## REGULAR MEETING CONSERVATION COMMISSION

4:00 P.M. July 9, 2025

## Memo

SUBJ: July 9, 2025 Conservation Commission Meeting

NOT FOR CONSTRUCTION

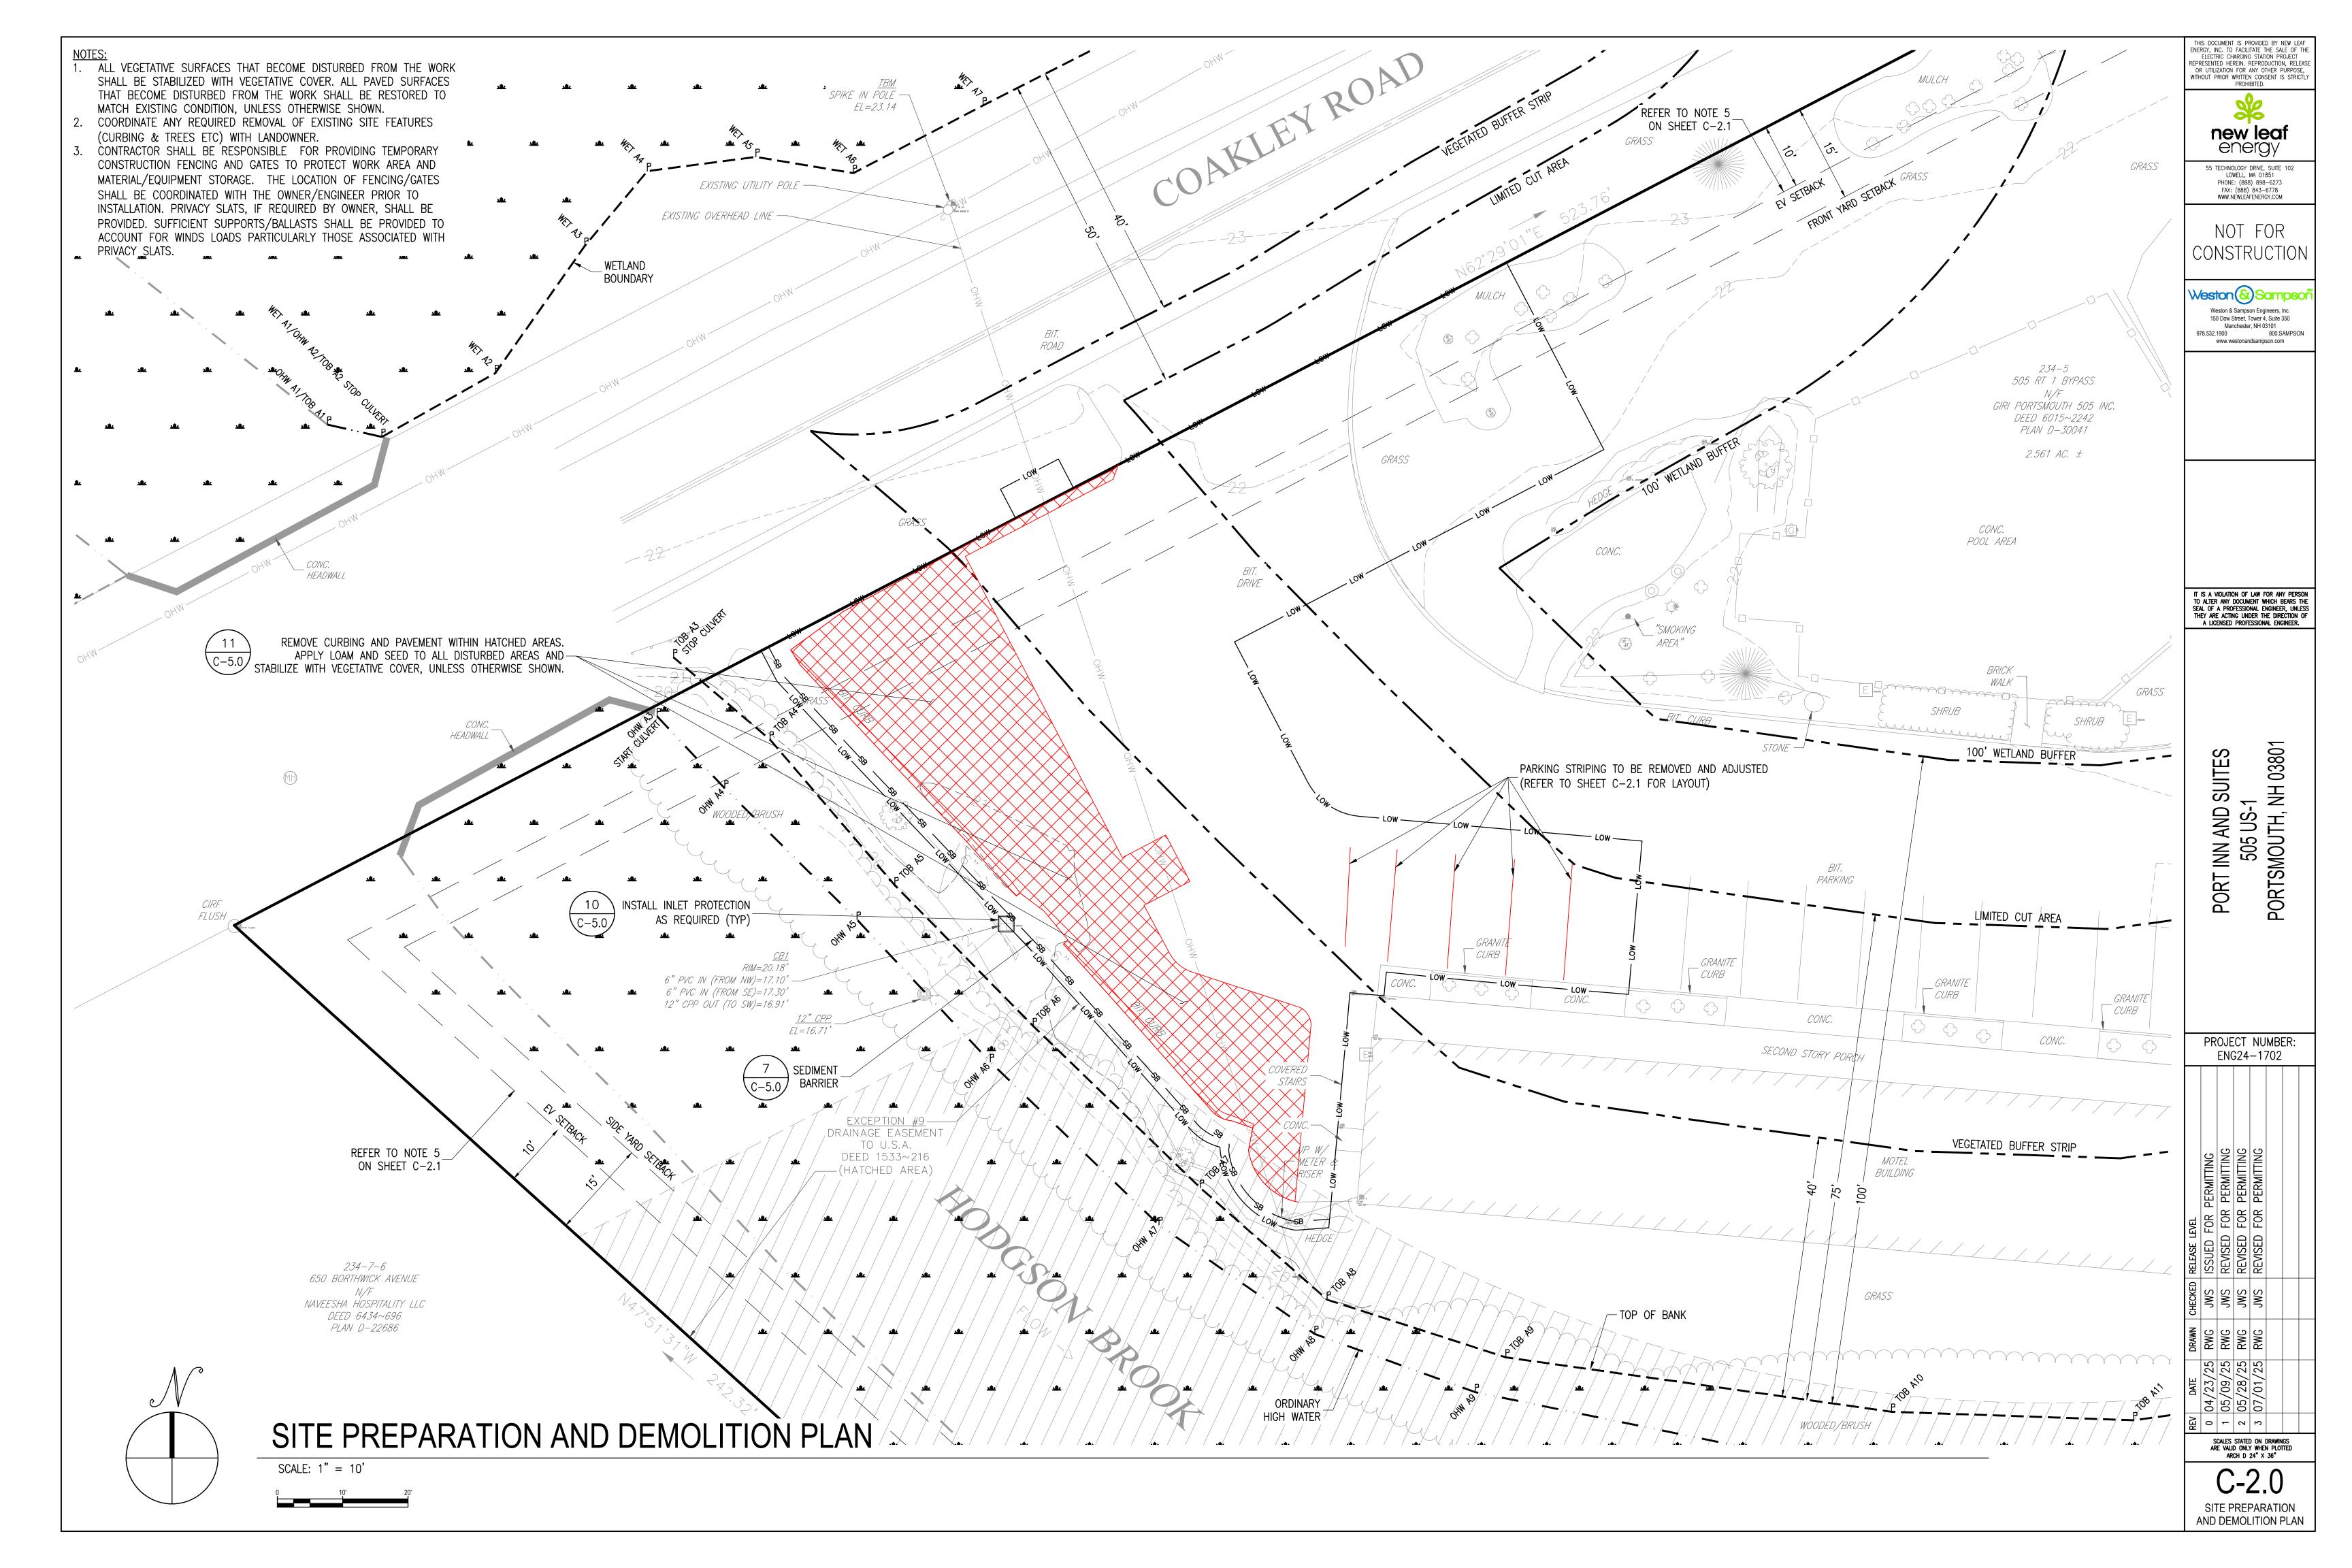
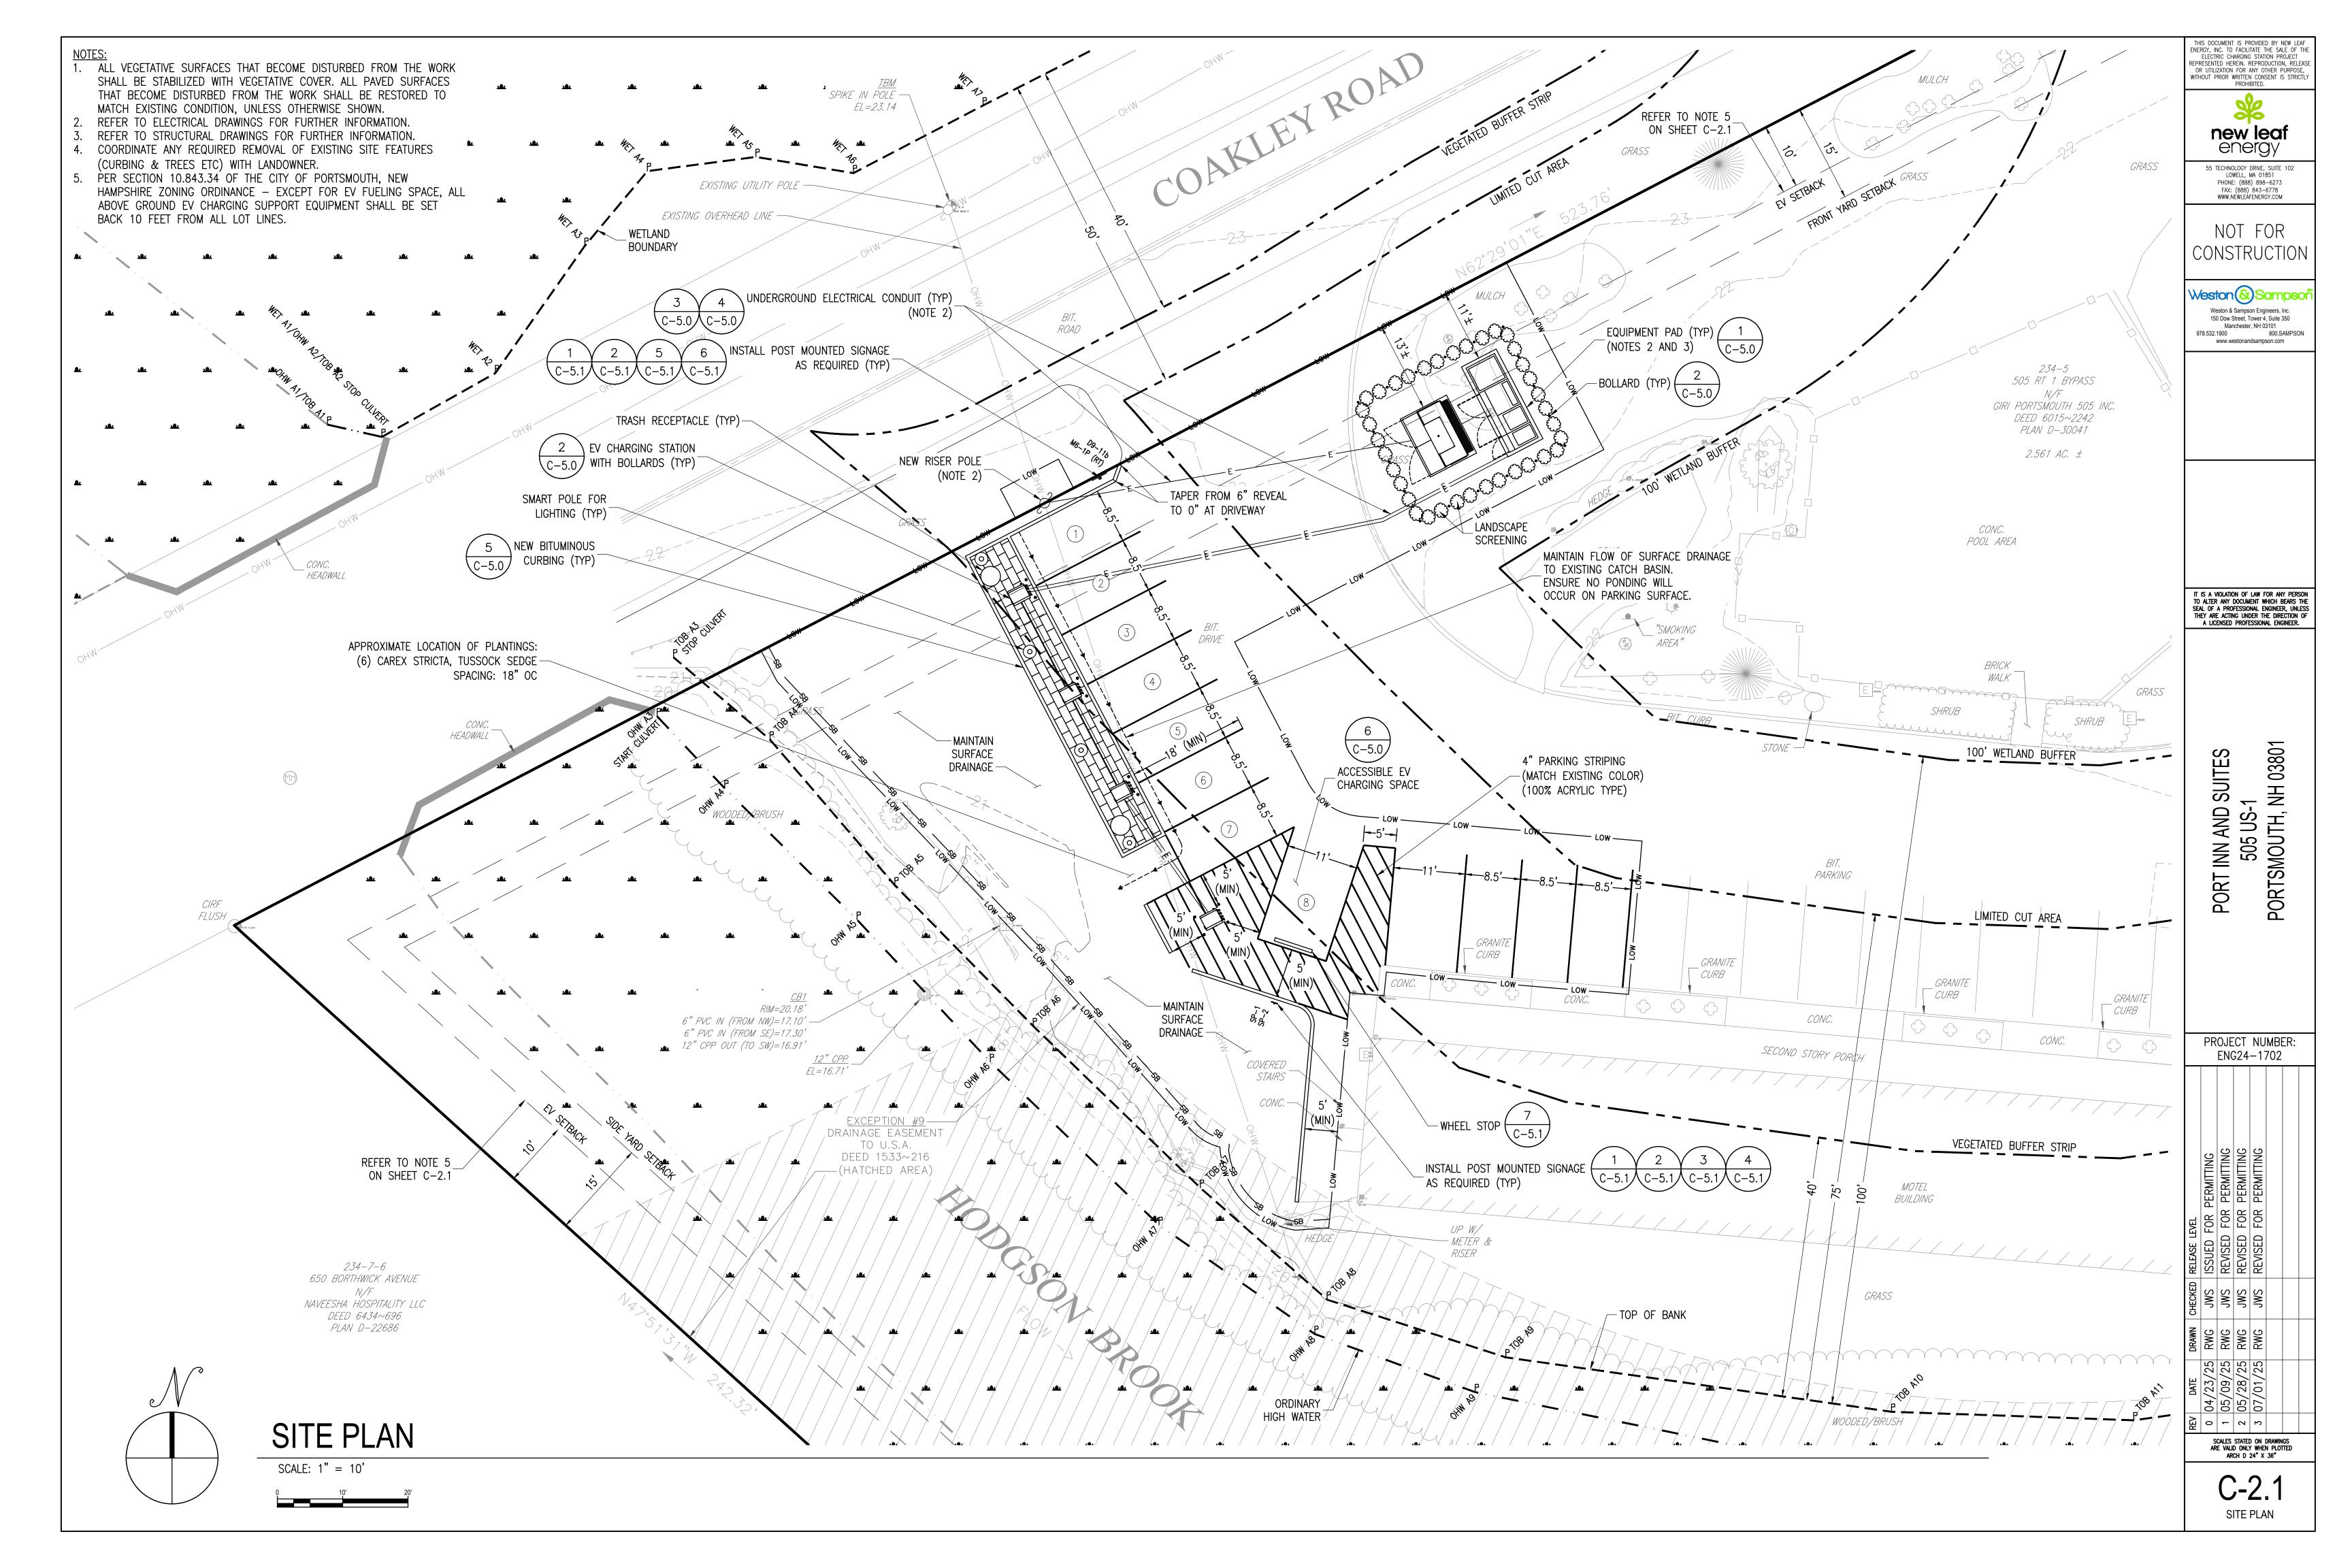
This project is for the installation of four new electric vehicle charging stations within the parking lot of the property. This would include creating and/or re-striping eight parking spaces and installing the necessary equipment and utility connections needed. This work will occur within the wetland buffer of Hodgson Brook and includes the removal of 2,135 s.f. of existing asphalt and converting to wetland buffer seeded area. It also includes 173 s.f. of permanent impacts to an existing landscape section within the buffer to install the transformer and concrete pads. In total, this project will create a net impervious of 1,962 s.f. within the 100' buffer.

The existing site is asphalt and is reasonably suited for the installation of such infrastructure.

The EV chargers have been located as far away from the wetland resource as possible while still being able to maintain the same number of parking spaces. The applicant is removing a significant amount of impervious from the vegetated buffer, planting native species and shifting the new infrastructure further from the brook.

The brook is already a heavily impacted resource and bolstering its buffer is critical to its protection. The removal of pavement between the proposed chargers and the brook will help to reclaim part of the wetland buffer. In addition to removing impervious, the applicants are also proposing to establish new plantings within the new pervious areas and maintain the intended existing drainage on the site.

This project proposes alterations with the construction of new transformers and concrete pads but plans to remove existing pavement and replant which will help offset those impacts.

The removal pavement from the 40' vegetated buffer strip and the installment of seed mix and plantings will be an improvement.

**Recommendation:** Staff recommends approval of this wetland conditional use permit to the Planning Board with the following conditions:

1. In accordance with Section 10.1018.40 of the Zoning Ordinance, applicant shall permanently install wetland boundary markers, which may be purchased through the City of Portsmouth Planning & Sustainability Department. Markers are to be placed along the 25' vegetative buffer at 50-foot intervals and must be permanently installed as a part of this after the fact permit.
